Delivered by hana
at November 18th, 2024
Committee of the Whole.

ALTERNATE ROUTE PRESENTATION

Proposed Bike Lane Network Phase 2

Combination of Protected and Un Protected Routes on Esquimalt Road

Archie Browning Protected Bike Lane with Buffer
with Small Car Parallel Parking Stalls
9 Parking Stall Loss (18 Large Vehicle Stalls (20ft/6m)
removed and 9 Small Vehicle Installed (16ft/5m)

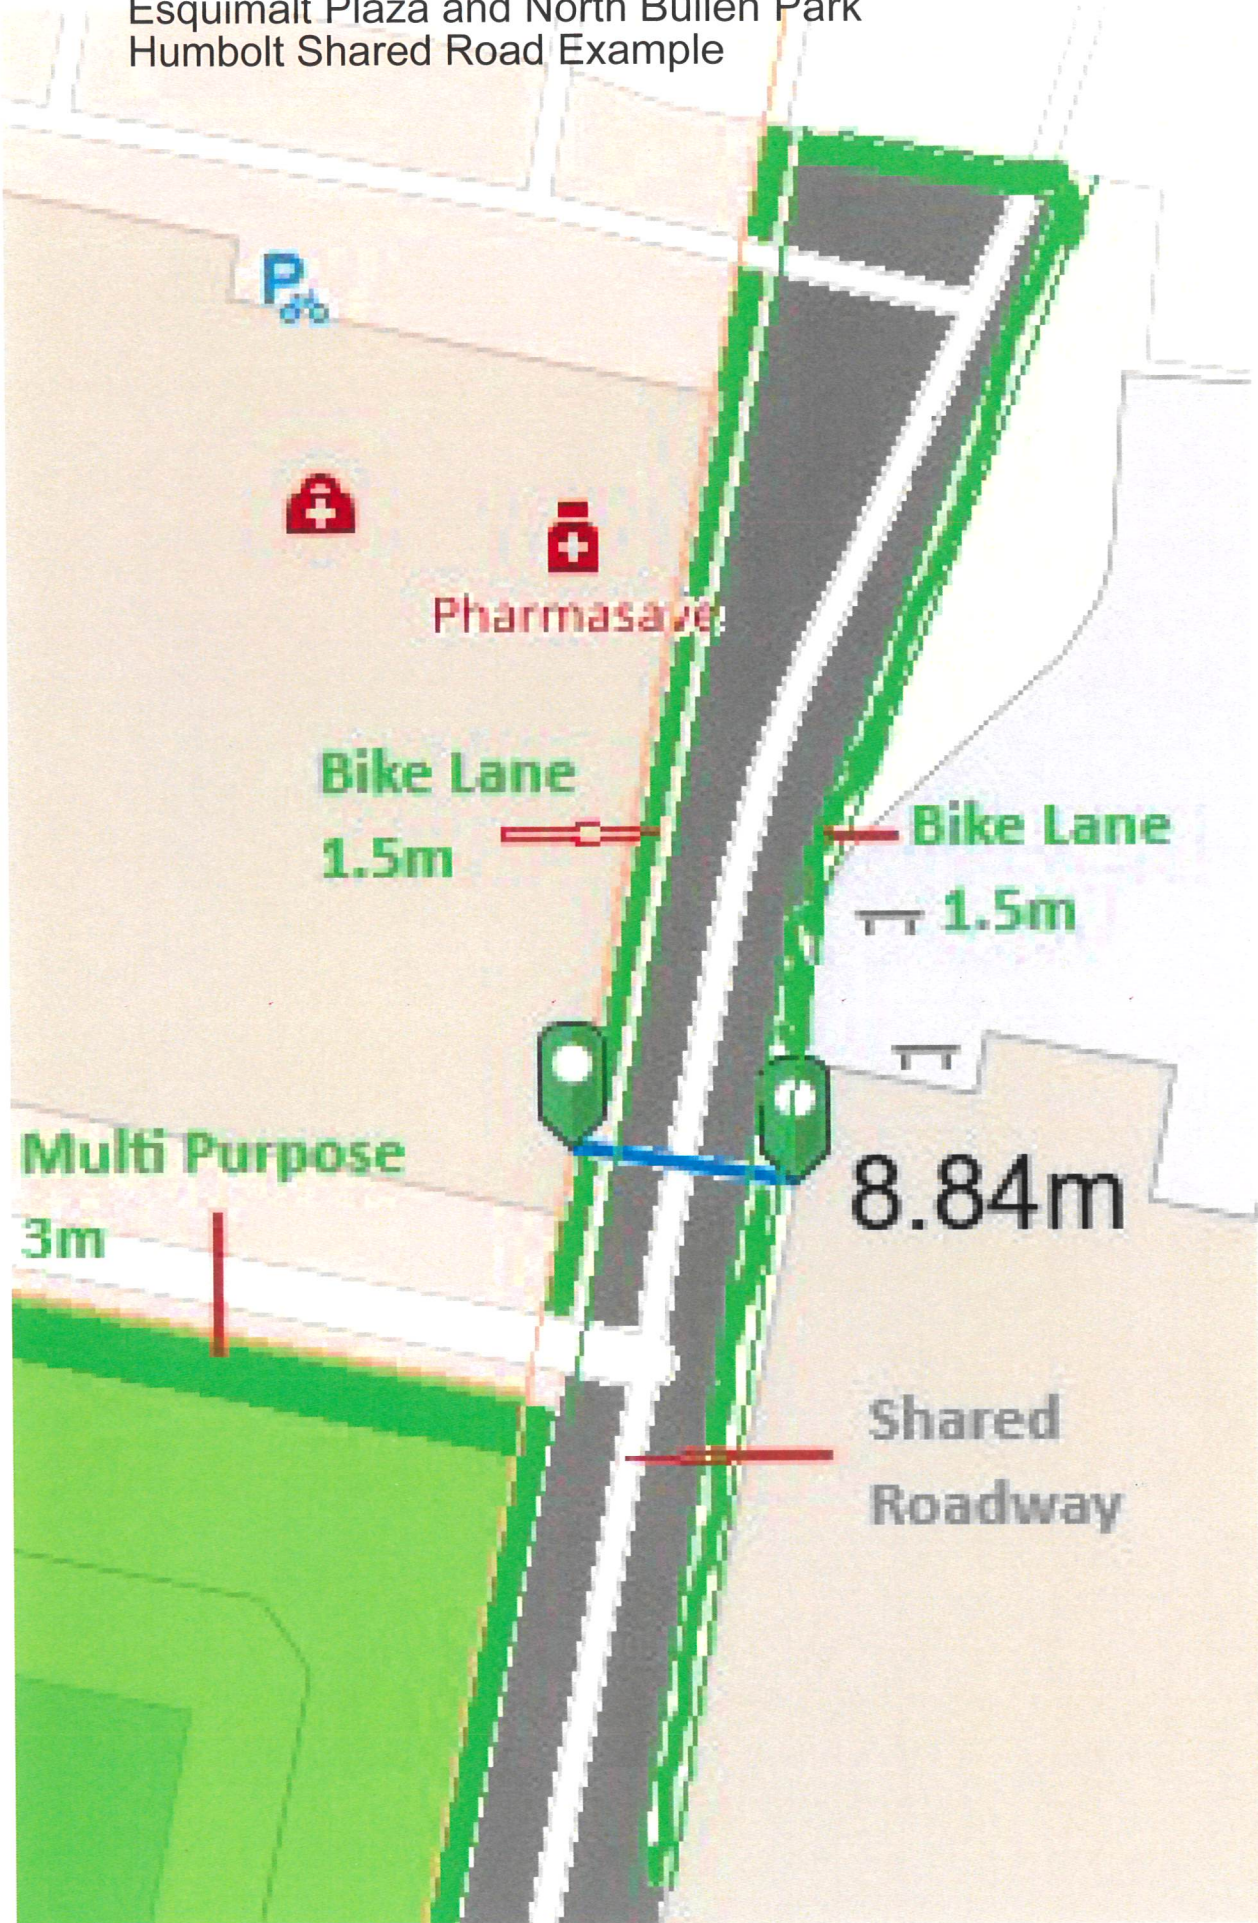
- **Not enough area between barrier and vehicle traveling surface of Archie Browning Center. False.** Current Vehicle 90 degree parking stalls are 20ft/6m. Within that footprint, as shown on attached, a multi-use route, buffer area and parallel parking for small car parking stalls is easily accommodated
- **Not enough width between Archie Browning Center and Esquimalt Plaza Building for Bike Lanes and Vehicle travel area. False.** As shown in photos of Humbolt Street shared routes can work in low traffic, low speed areas. The section between buildings is 30ft/9.1m in width which can easily accommodate two

1.5m unprotected lanes and a 6m(20ft) driving surface is attainable.

North Bullen Park to Esquimalt Rec Center
3m Multi Purpose Path
*1.2m additional Concrete width to be added to existing 1.8m Concrete Path
No conflict with existing Trees

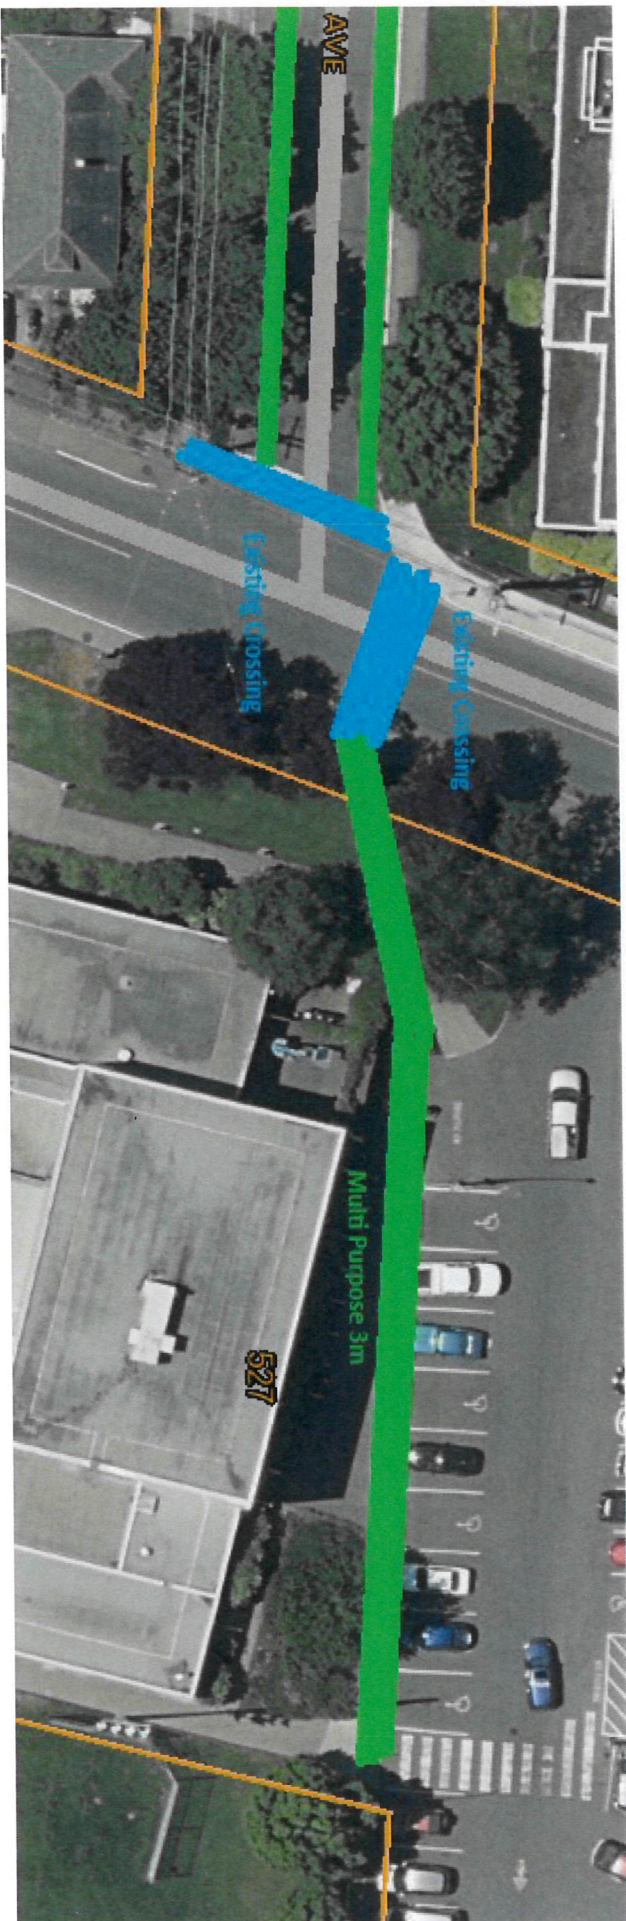
- **Widening of concrete to construct Multipurpose path will impact trees. False.** *Firstly, is Engineering suggesting that protecting 11 trees is more important than protecting the Businesses impacted by the removal of street parking along Esquimalt Road?*

Current path is 1.8m in width. Only 1.2m of widening is required which should not impact the trees. Municipal roads are widened all the time along treed routes. If, in the event the impacts are significant, then trees can be replanted for minimal cost (\$500 per tree) compared to the losses inflicted on the lives of business owners and their employees.

Esquimalt Recreation Center to Carlisle Protected Bike Lane with Crossings

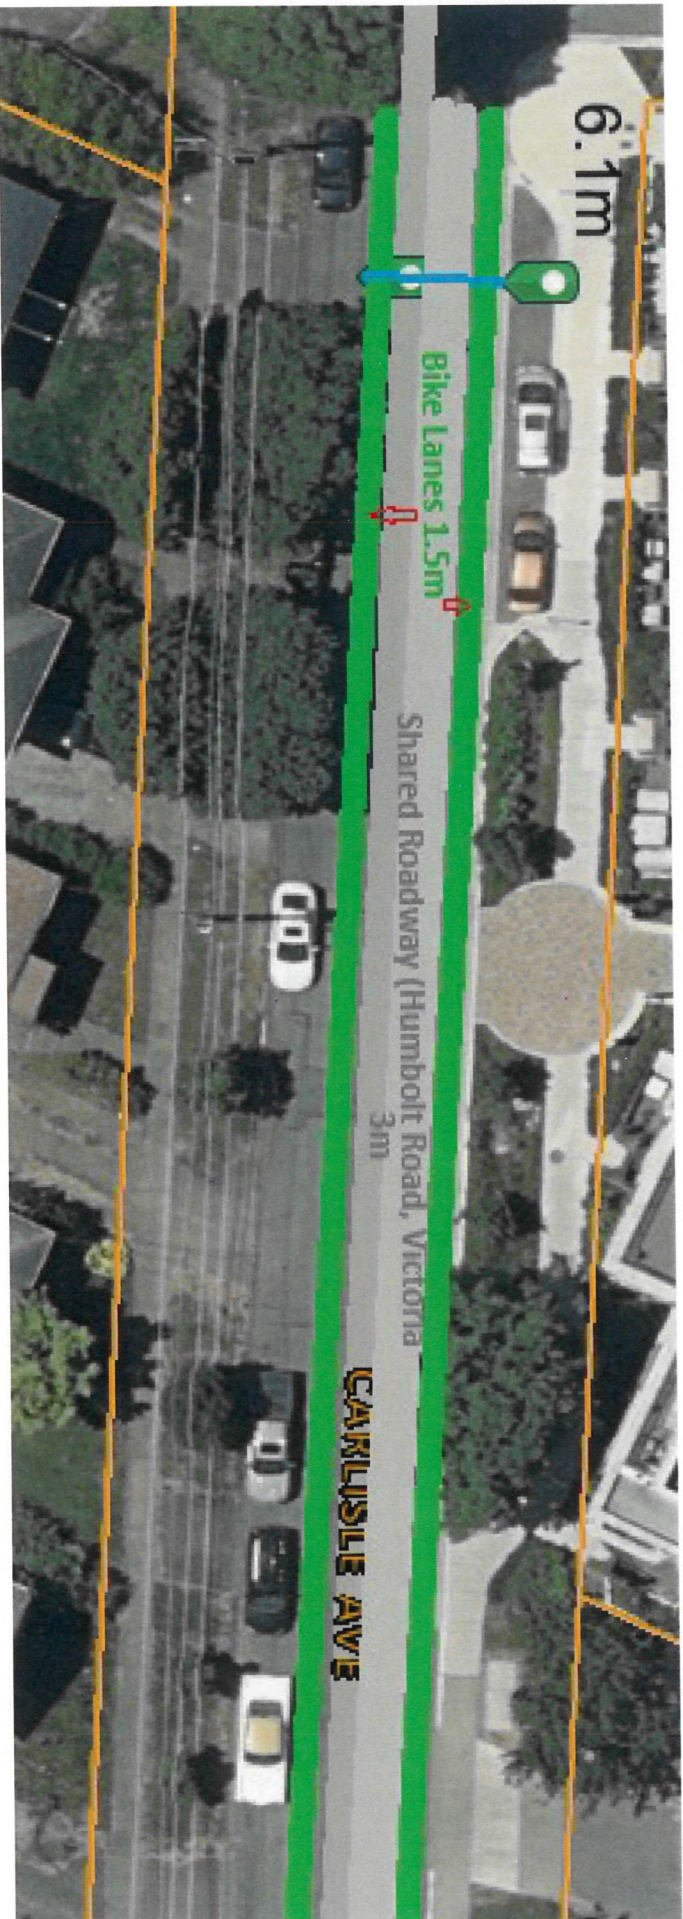
- **Multi Purpose Path in area next to Rec Center would impact the parking lot. False.** *Engineering appears concerned about Rec Center parking but not parking for Businesses.* The extension of the multipurpose path through the Rec Center property would require changes to the landscape planters on the east side and west side of the Rec Center but not have an impact on Rec Center parking. Bike riders may have to be responsible and dismount through this area as they approach the Fraser Street Crossing for the safety of pedestrian and mobility challenged users.
